DUKE POWER COMPANY

OCONEE NUCLEAR STATION

ATTACHMENT 1

TECHNICAL SPECIFICATIONS

Figure 3.4.3-5 (page 1 of 1)  
RCS Normal Operational Cooldown Limitations  
Applicable for the First 33 EFPY - Oconee Nuclear Station Unit 2

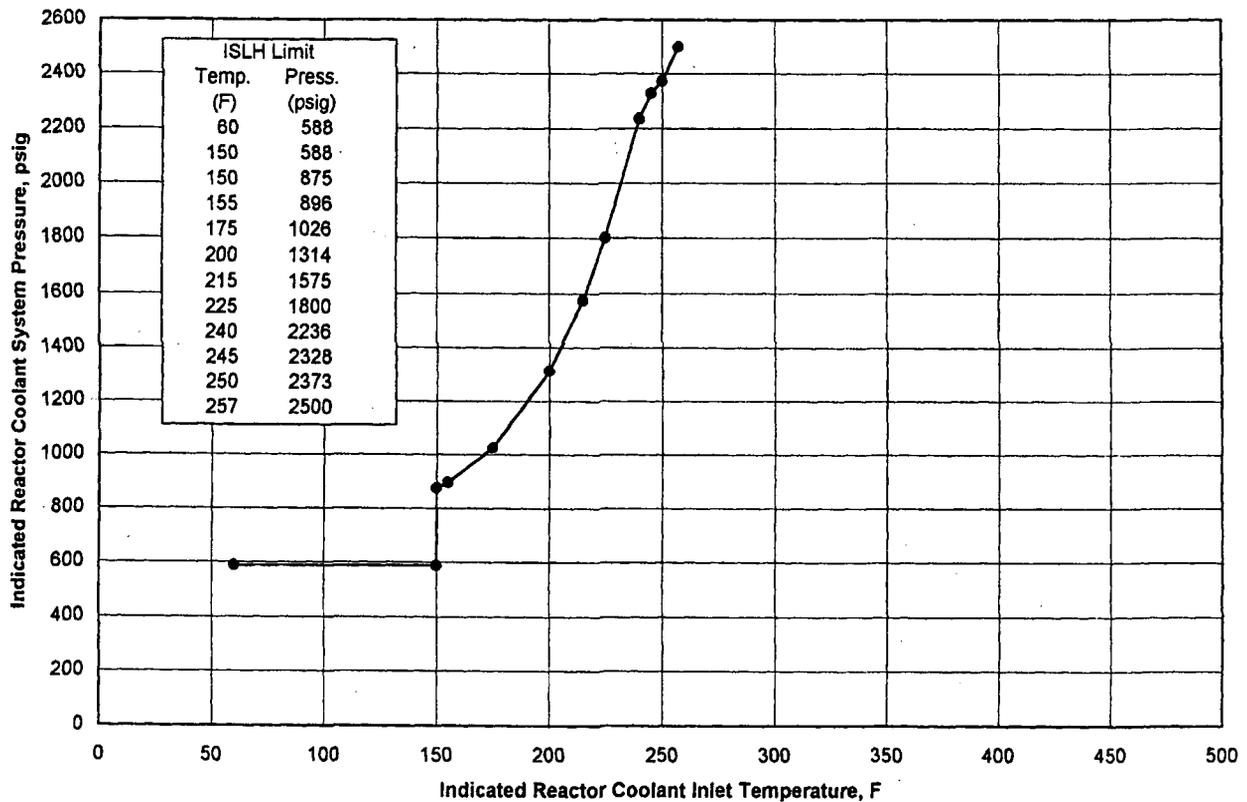
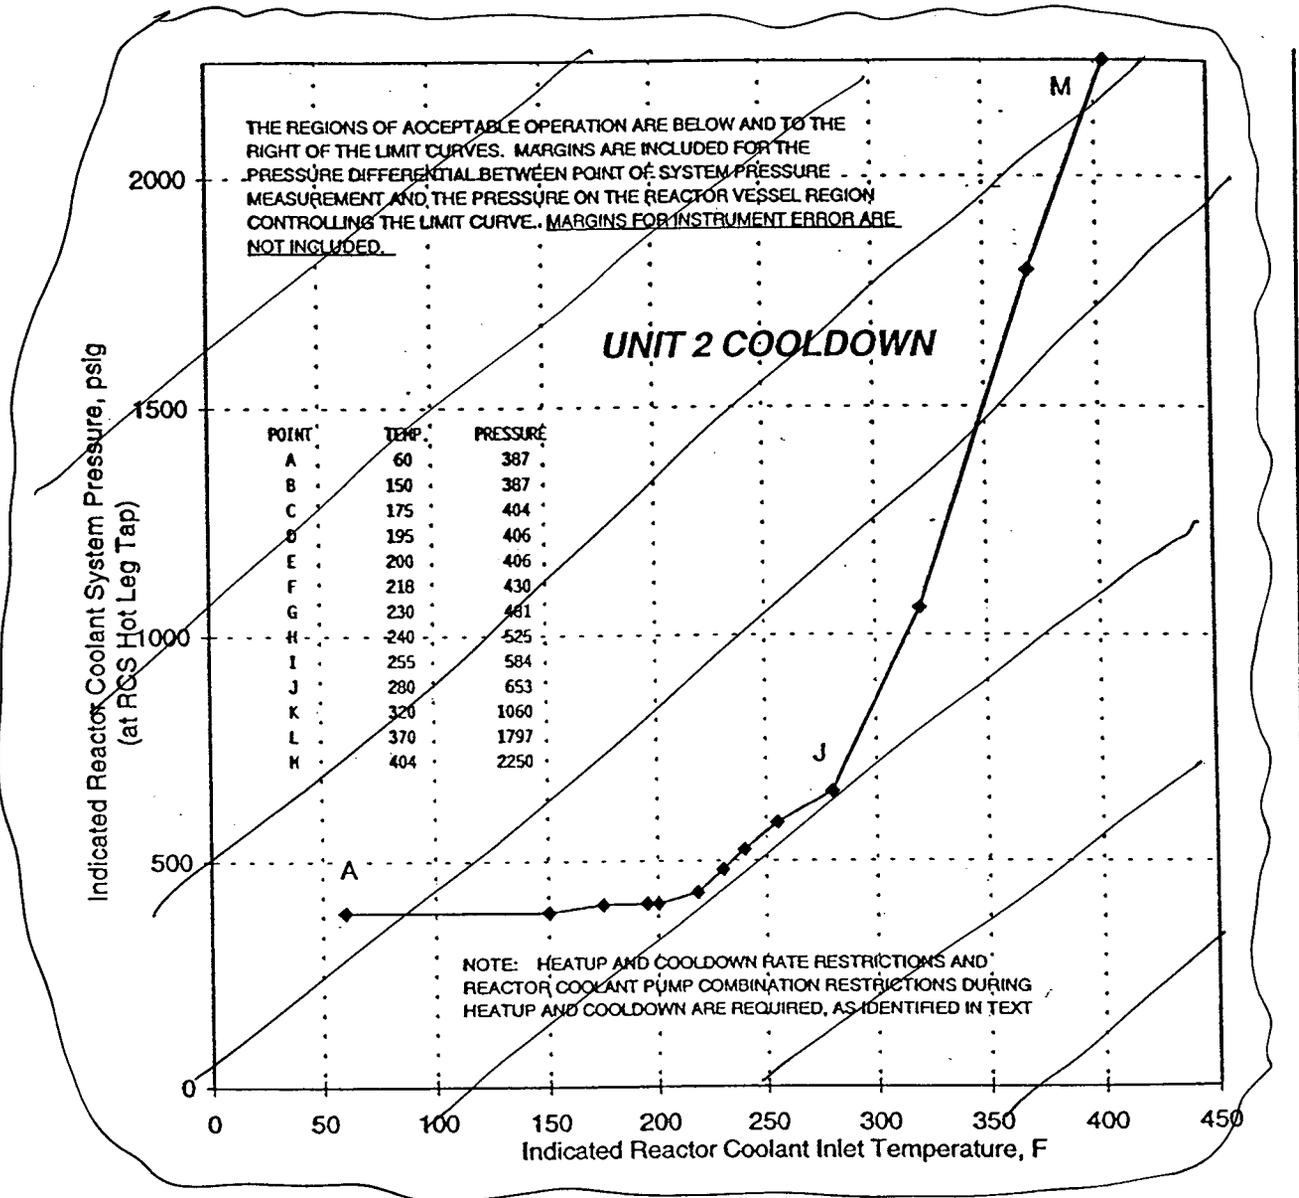
Figure 3.4.3-5 (page 1 of 1)  
RCS Normal Operational Cooldown Limitations  
Applicable for the First 26 EPFY - Oconee Nuclear Station Unit 2

33

Figure 3.4.3-6 (page 1 of 1)  
RCS Leak and Hydrostatic Test Heatup and Cooldown Limitations  
Applicable for the First 33 EFPY - Oconee Nuclear Station Unit 2

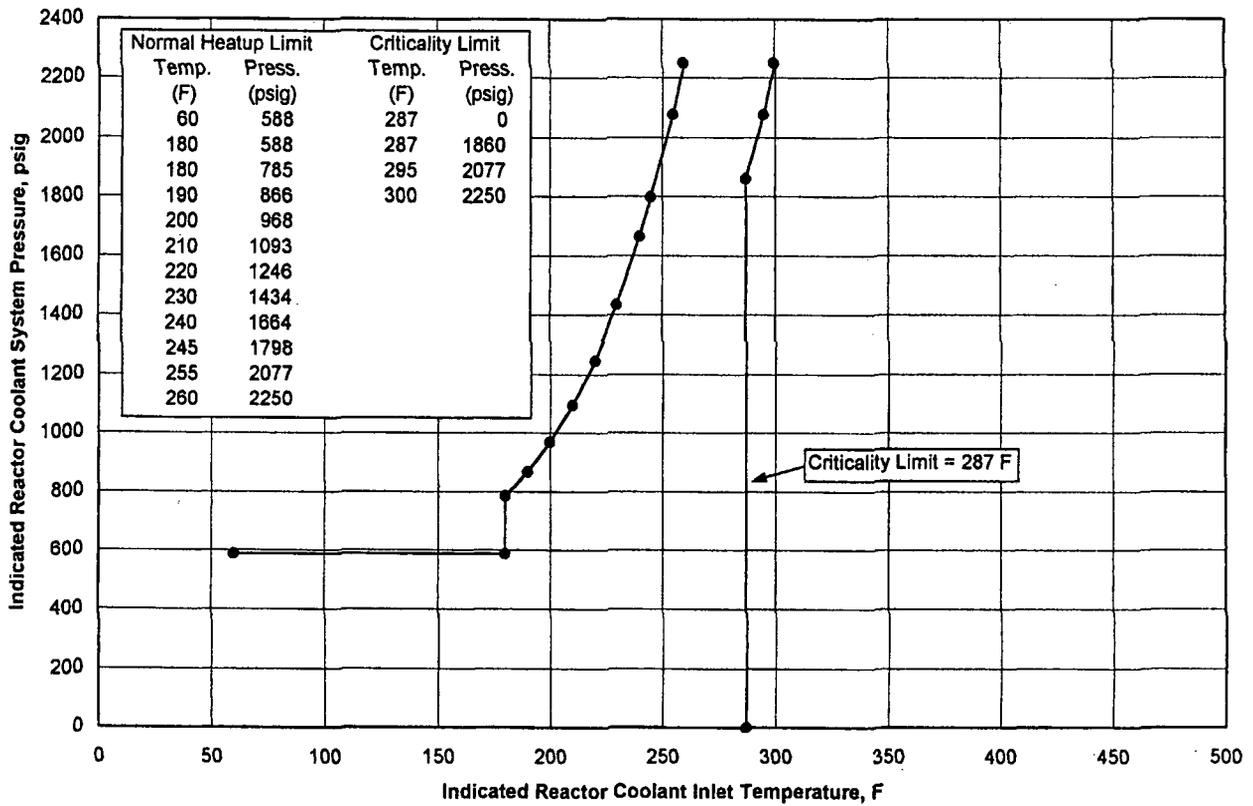
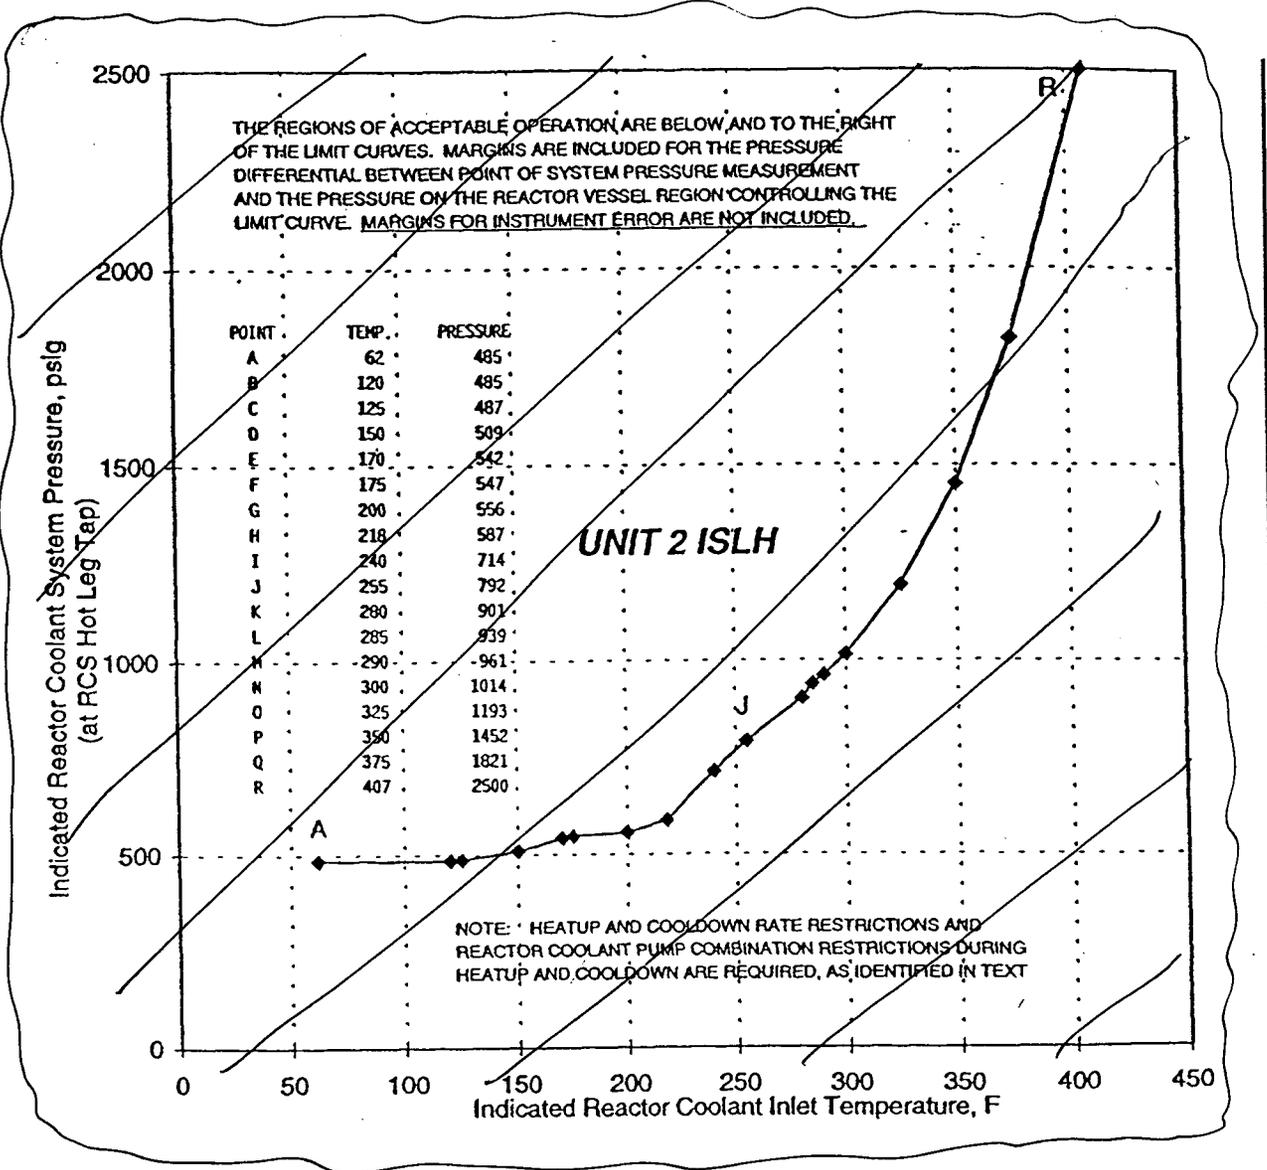
Figure 3.4.3-6 (page 1 of 1)  
RCS Leak and Hydrostatic Test Heatup and Cooldown Limitations  
Applicable for the First 26 EFY - Oconee Nuclear Station Unit 2

26  
33

Figure 3.4.3-7 (page 1 of 1)  
RCS Normal Operational Heatup Limitations  
Applicable for the First 33 EFPY - Oconee Nuclear Station Unit 3

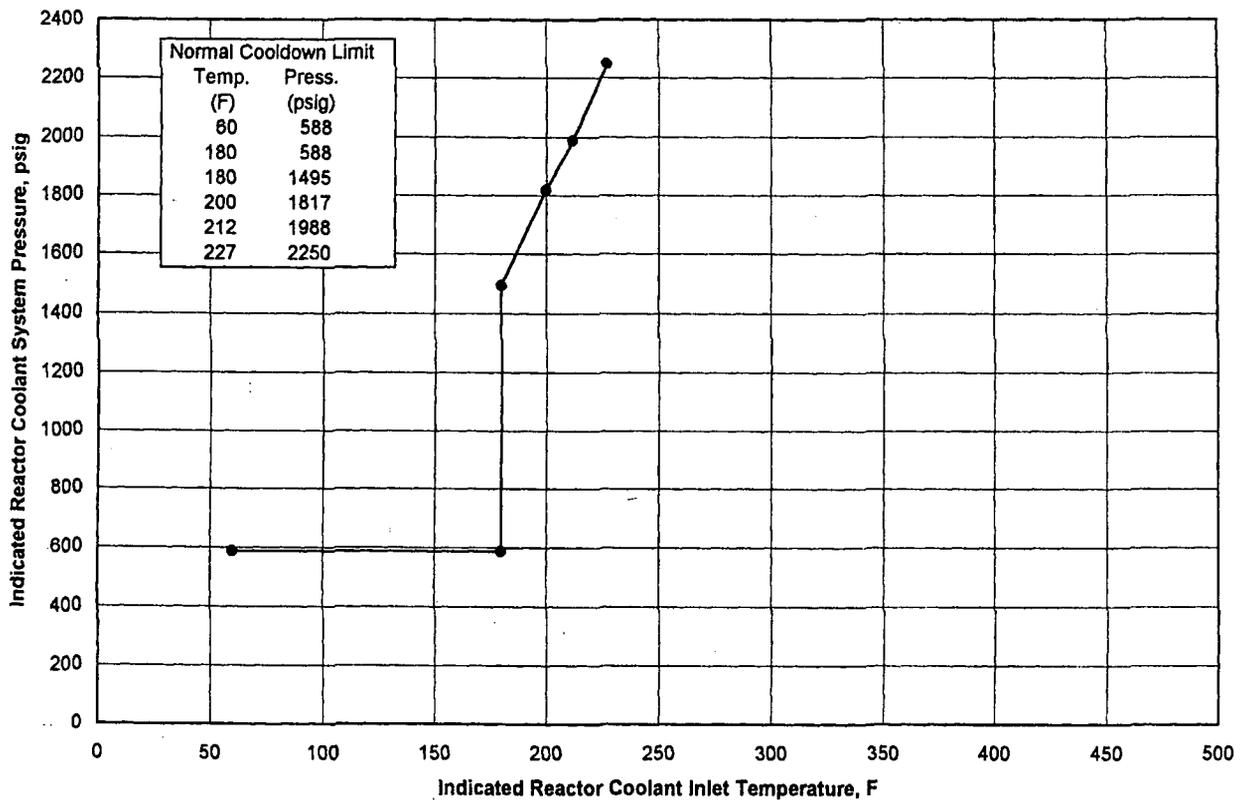
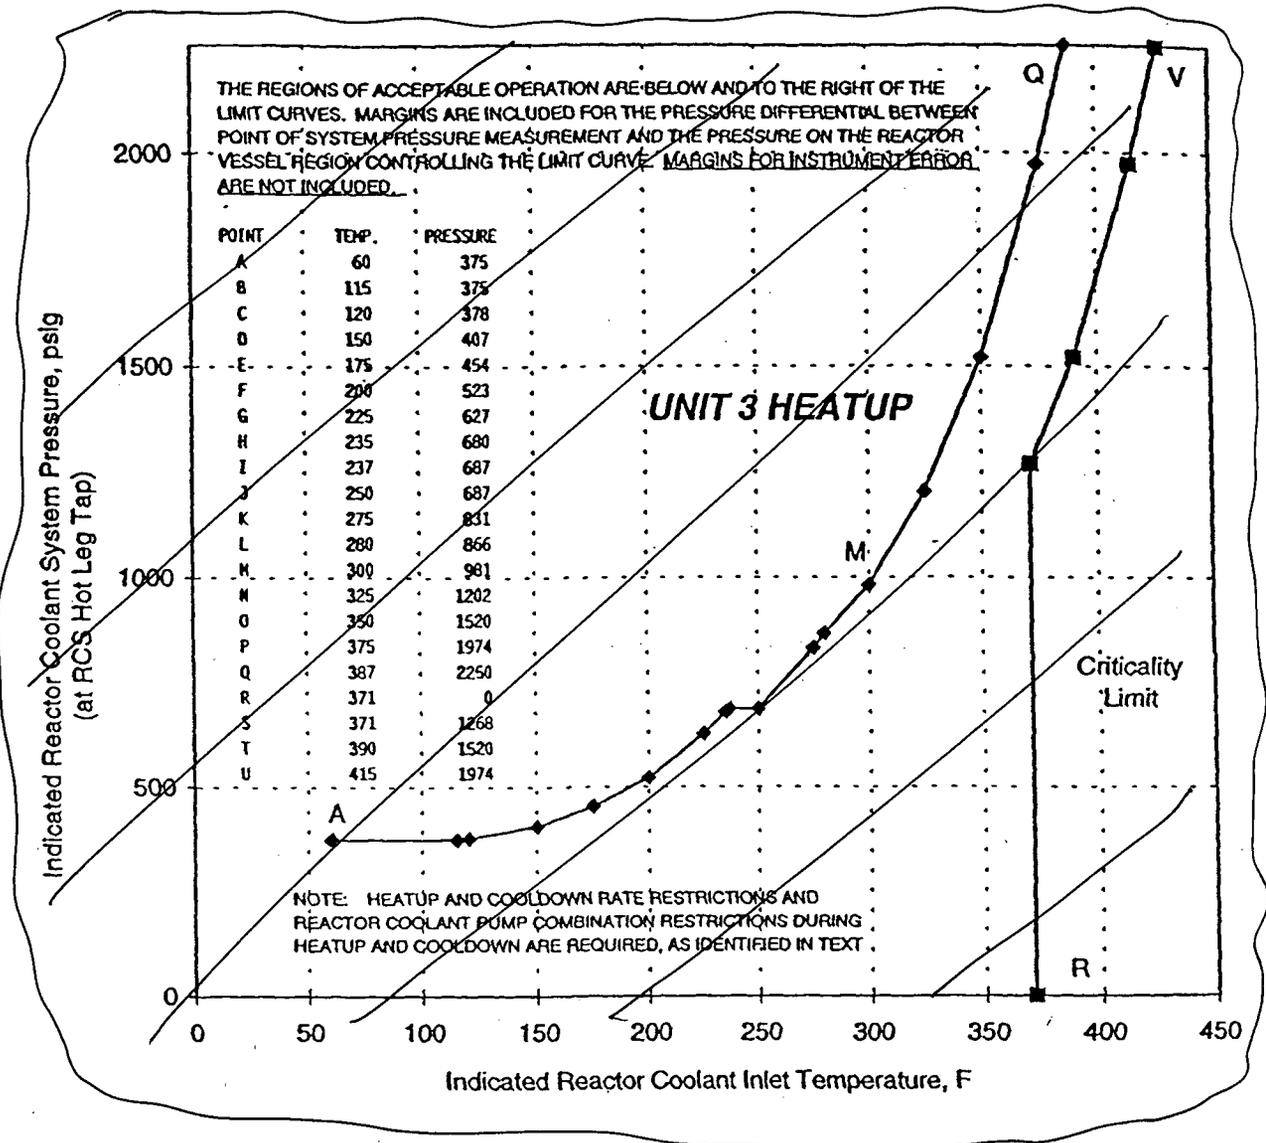
Figure 3.4.3-7 (page 1 of 1)  
RCS Normal Operational Heatup Limitations  
Applicable for the First 20 EFY - Oconee Nuclear Station Unit 3

33

Figure 3.4.3-8 (page 1 of 1)  
RCS Normal Operational Cooldown Limitations  
Applicable for the First 33 EFPY - Oconee Nuclear Station Unit 3

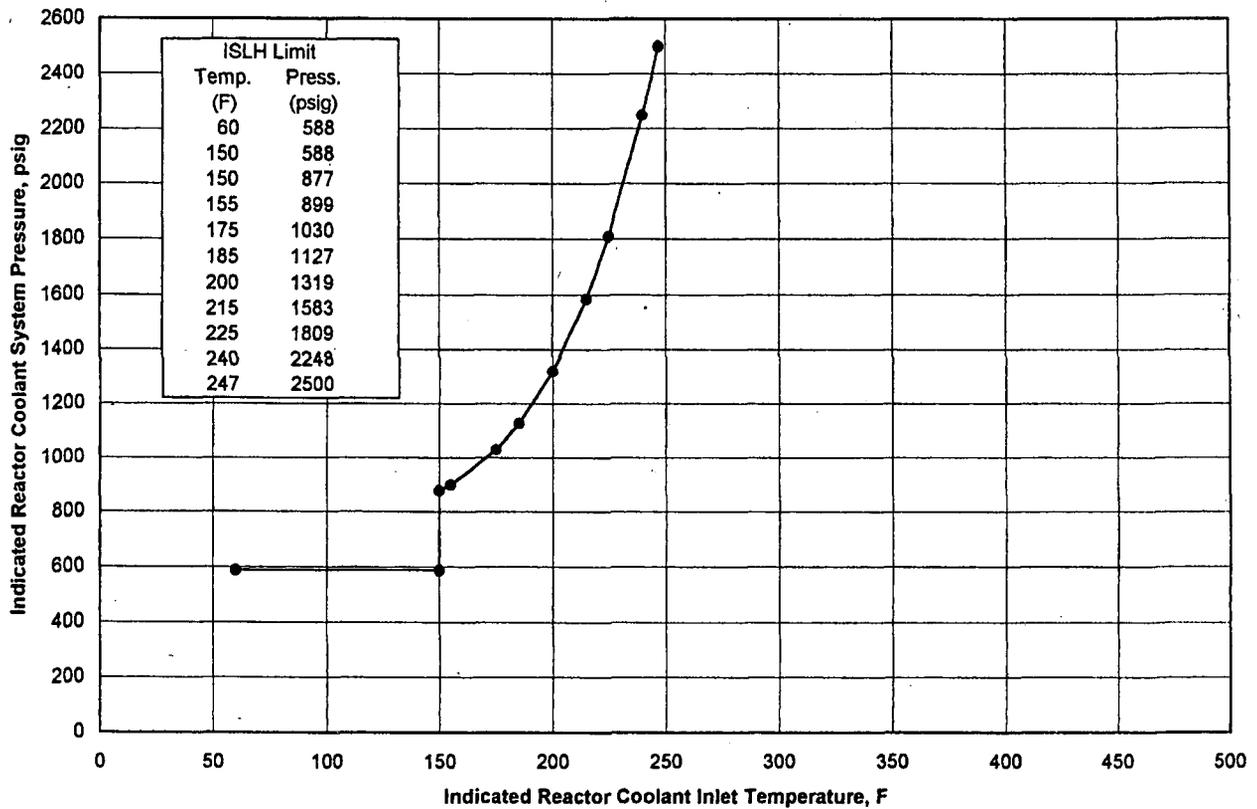
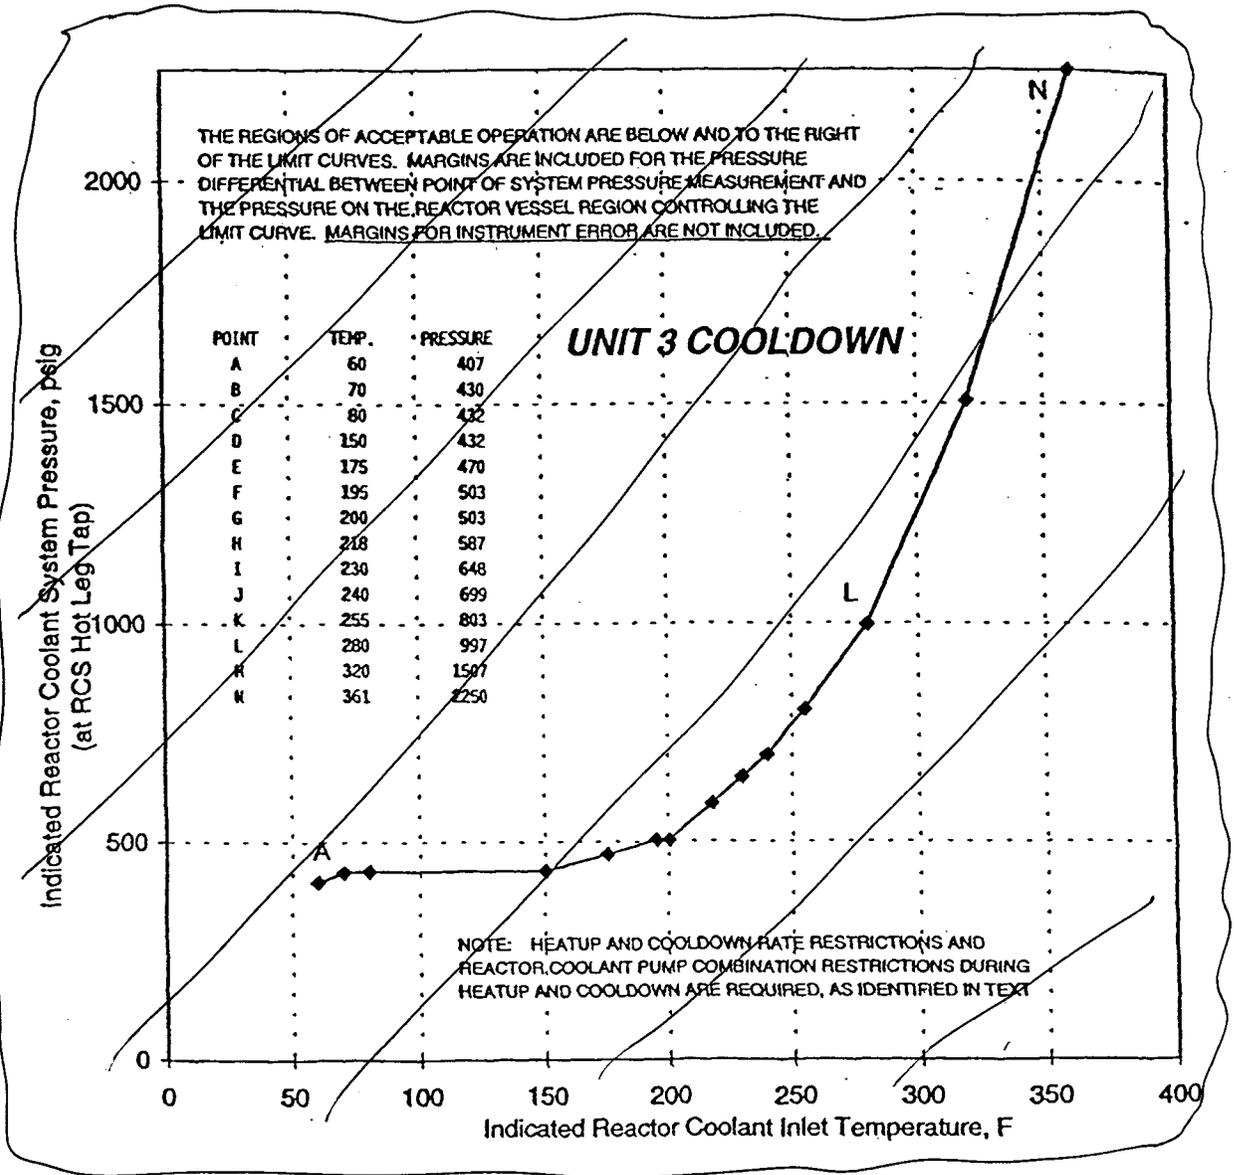
Figure 3.4.3-8 (page 1 of 1)  
RCS Normal Operational Cooldown Limitations  
Applicable for the First 26 EFY - Oconee Nuclear Station Unit 3

33

Figure 3.4.3-9 (page 1 of 1)  
RCS Leak and Hydrostatic Test Heatup and Cooldown Limitations  
Applicable for the First (26) EFY - Oconee Nuclear Station Unit 3

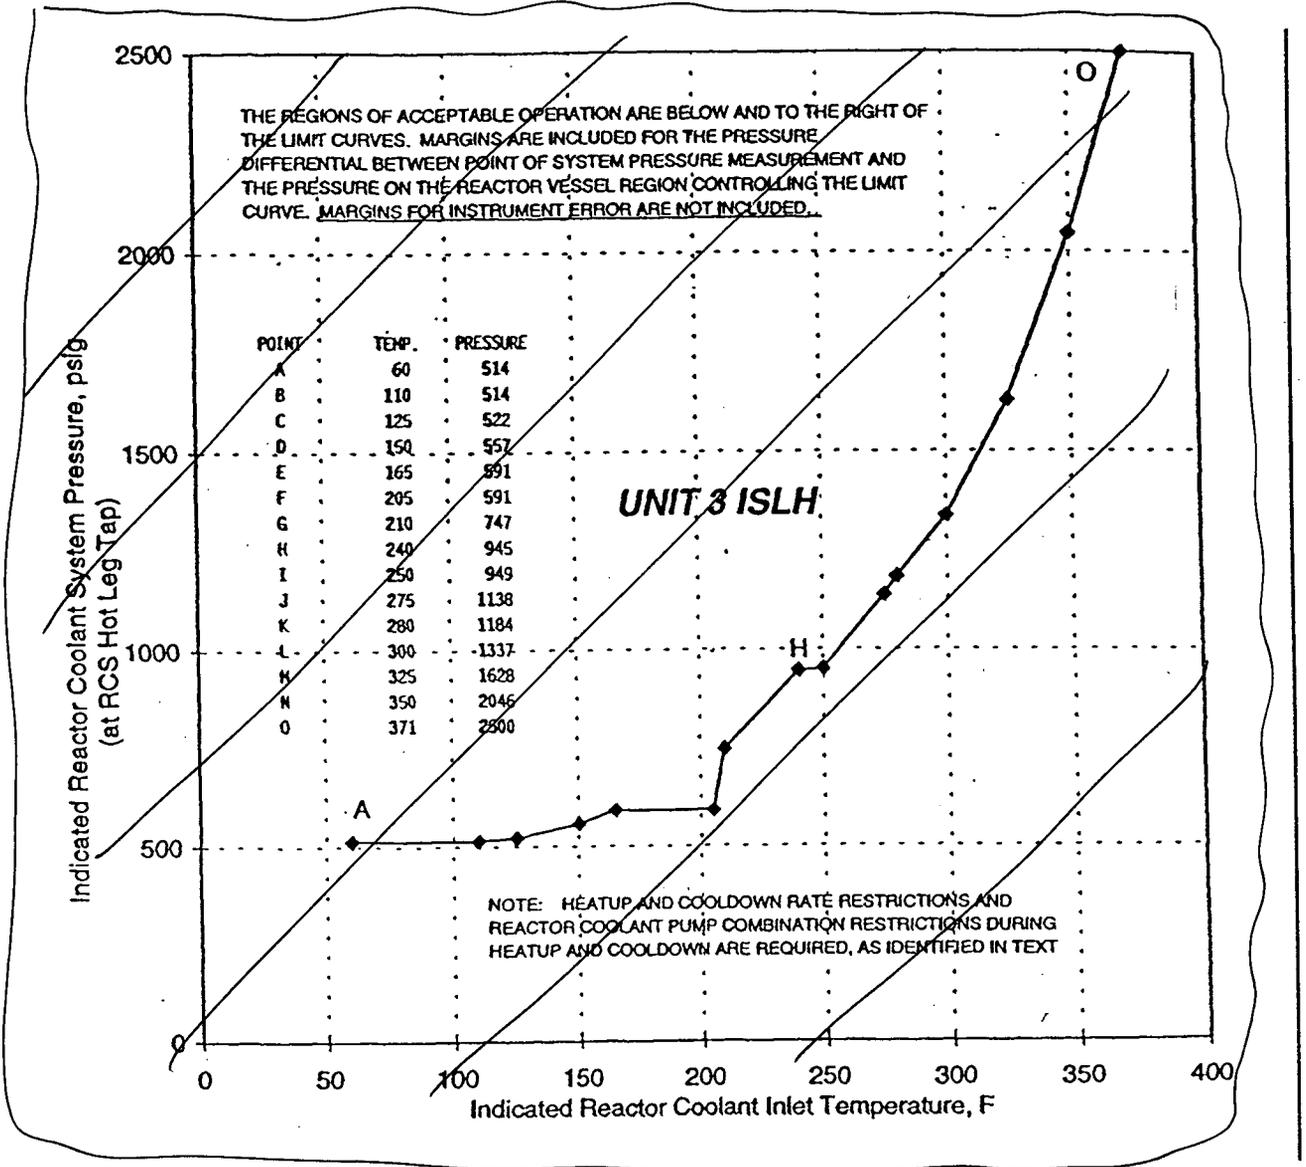
33
